SUNDRY NOTICES AND REPORTS ON WELLS

Energen Resources plans to plug and abandon the Jicarilla 15 #1 per the attached procedure.

PLUG AND ABANDONMENT PROCEDURE

Jicarilla 15 #1

Current

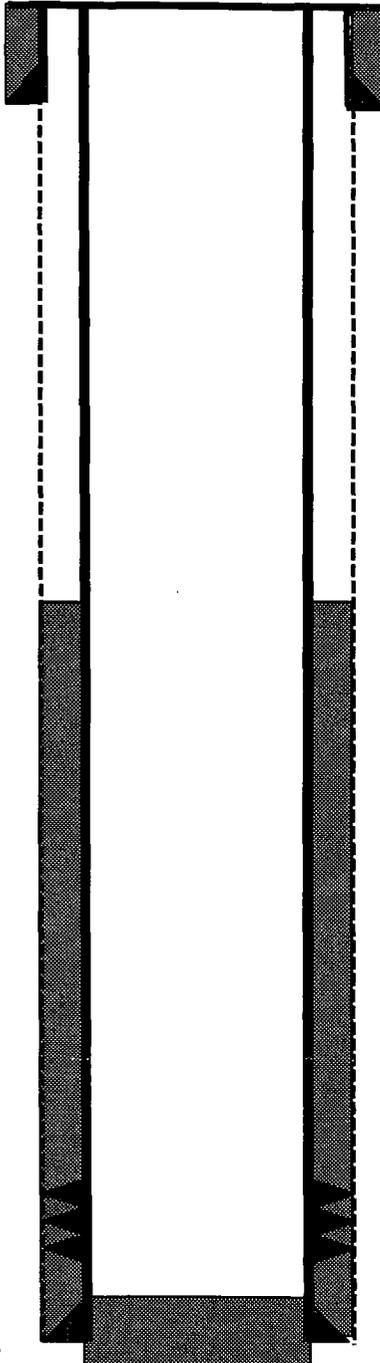
1. Plugging operations authorized are subject to the attached "General Requirements for Permanent Abandonment of Wells on Federal and Indian Lease."
2. Farmington Office is to be notified at least 24 hours before the plugging operations commence (505) 564-7750.
3. Bring the top of plug #2 to 1215 ft. inside/outside to cover the Nacimiento formation top. Adjust cement volume accordingly

Operator will run a CBL from 2917 ft., or as deep as possible, to verify cement top. Outside plugs may be revised, based on CBL result. Submit electronic copy of the log for verification to the following BLM and NMOCD address: tsalyers@blm.gov, Brandon.Powell@state.nm.us
